City of Franklin

Franklin Municipal Planning Commission

Thursday, September 28, 2017

1. C. Final Plat

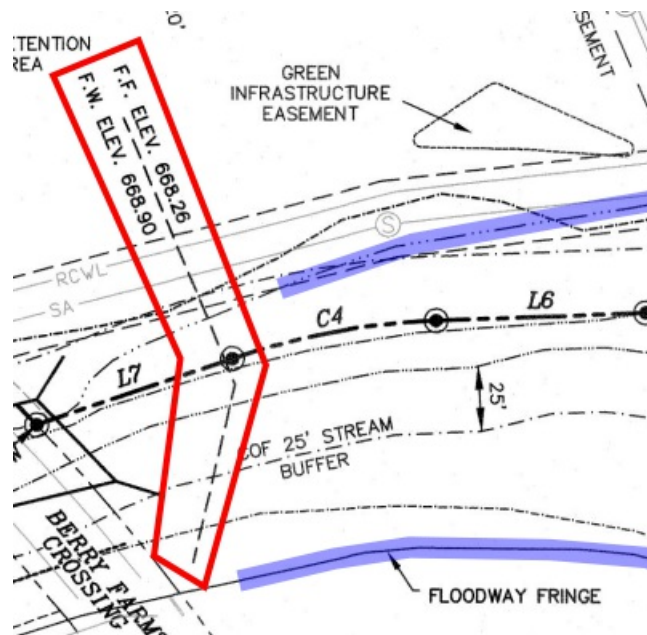
tomi@franklintn.gov The previous comment "The applicant shall show all drive aisle access easements on the lot such that one or more continuous paths are available between adjoining lots and/or public streets. This issue applies to the drive aisle between this lot and the adjacent lot to the north. The drive aisle is shared between the lots. For connectivity the shared drive aisle access must continue to an entrance to the public street." was not completely addressed. The Drive Aisle Access Easement must continue to an actual drive able access to the public street.

22. Domestic water

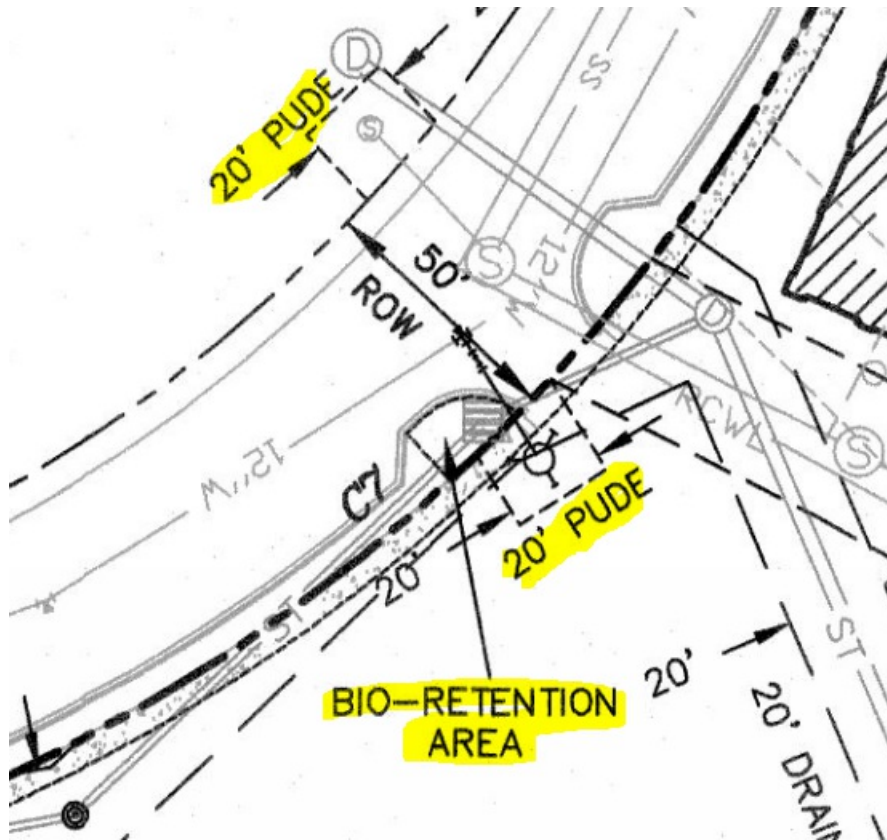
ben.mcneil@franklin.tn.gov Applicant failed to address issue, applicant shall ensure the storm and domestic water match the revisions made on site. My records indicate that the bio-retention was revised to allow for separation of the water. The field inspector has confirmed that a revision was completed in the field to ensure the bio-retention and easements are separate.

23. Domestic water

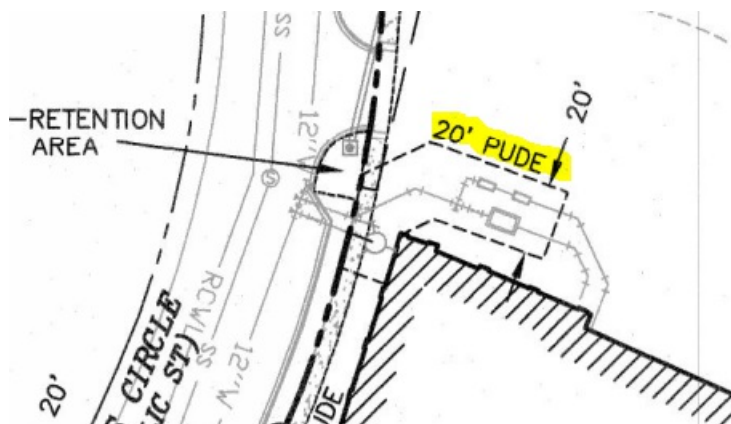
ben.mcneil@franklin.tn.gov Applicant did not fully address the issue, applicant did add an easement, but the PUDE is not acceptable. All Franklin water, sanitary sewer and reclaim lines are to be shown in exclusive easements.

8. 0. General Information

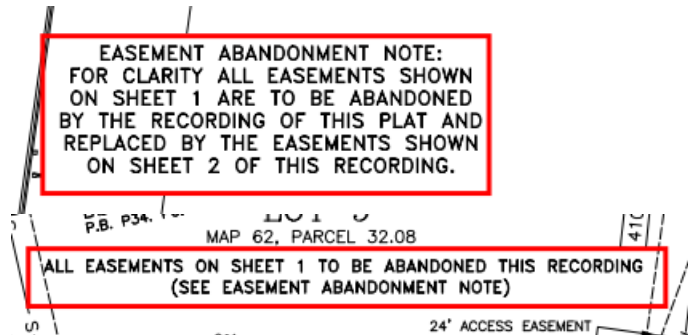
joe.marlo@franklin.tn.gov *Comment to remain open while COF 6512 is still under review.*

Applicant shall ensure that modifications to the site plan (COF 6512), which is being reviewed concurrently with this final plat, are reflected on the final plat. The final plat shall match the site plan, including all easement modifications requested on the associated site plan submittal.

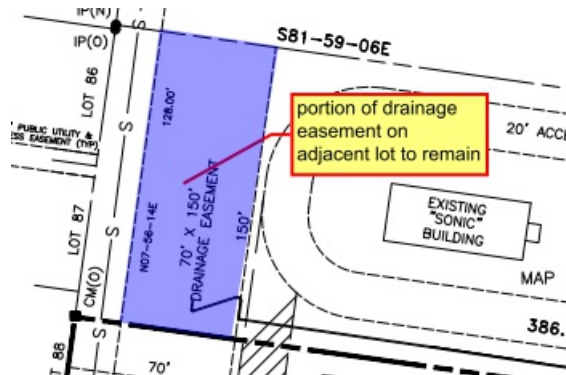
1. Revise notes noted below clarifying that only Lot 9 easements are to be abandoned.

2. Show the portion of the drainage easement in the back of Lot 5 on Sheet 2 of 2, as this portion is not being abandoned. On Sheet 2, Applicant to revise the "70' x 150' Drainage Easement" call-out for this easement to state "Drainage Easement P56, PG. 126".

12. C. Final Plat

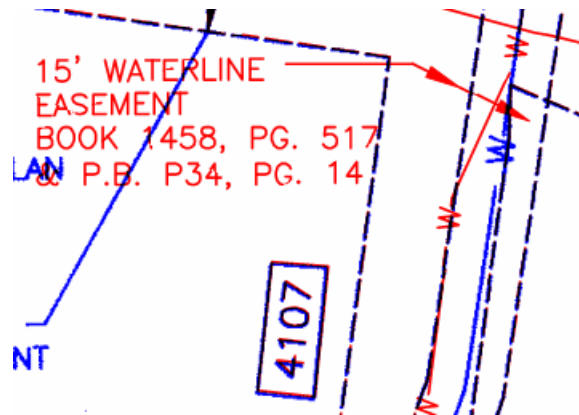
joe.marlo@franklin.tn.gov Comment not adequately addressed. Old plat reference is still shown on north arrow on Sheet 1 and north arrow has now been deleted on Sheet 2.

Remove North Arrow reference to a plat that, with the recording of this plat, will be two revisions back. Provide North Arrow on Sheet 2.

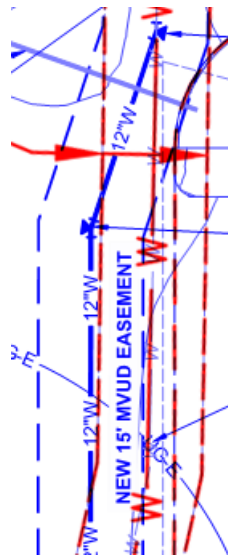
1. The existing waterline location and arrow leaders from easement call-out on Sheet 1 of 2 are incorrect (previous plat in blue, proposed plat in red). Applicant to correct on plat.

2. The proposed waterline location and easement shown on Sheet 2 of 2 does not match the location shown on Site Plan C5.0 (COF 6512) (Site Plan in blue, proposed plat in red). Applicant to correct on plat.

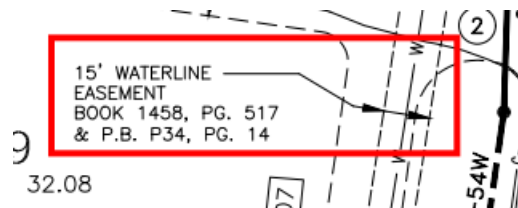
joe.marlo@franklintn.gov The following is a newcomment based on newinformation shown.

The Deed and Plat Book reference for the waterline on Sheet 2 is no longer valid if a new easement is being created. Applicant to confirm with Water Utility and revise plat accordingly.

26. C. Final Plat

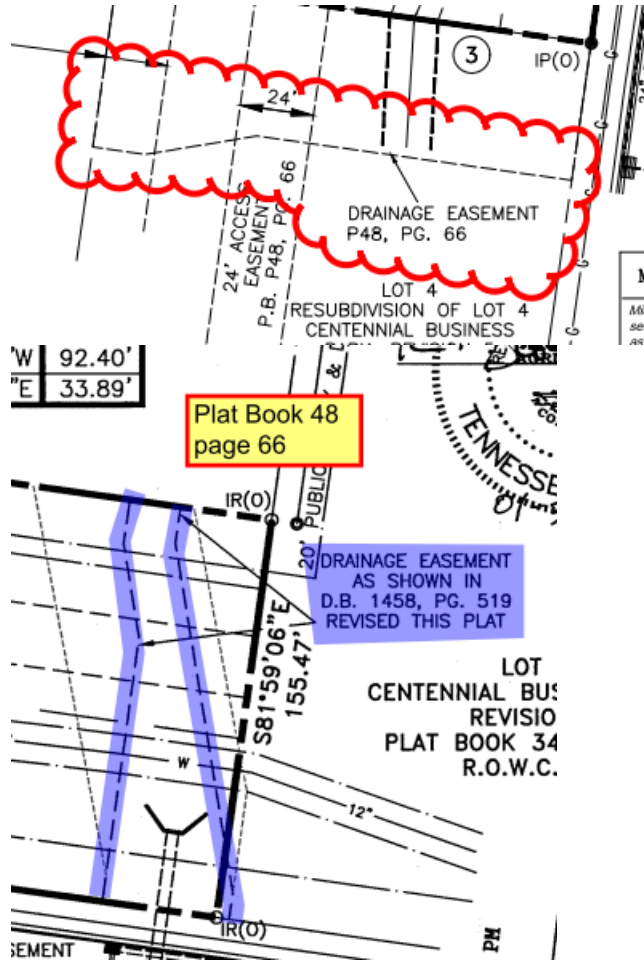
The Drainage Easement on Lot 4 is to appear on both Sheets 1 and 2 (currently only shown on Sheet 1). Note that the easement does not appear to match the plat with which it was created. Applicant to revise plat accordingly.
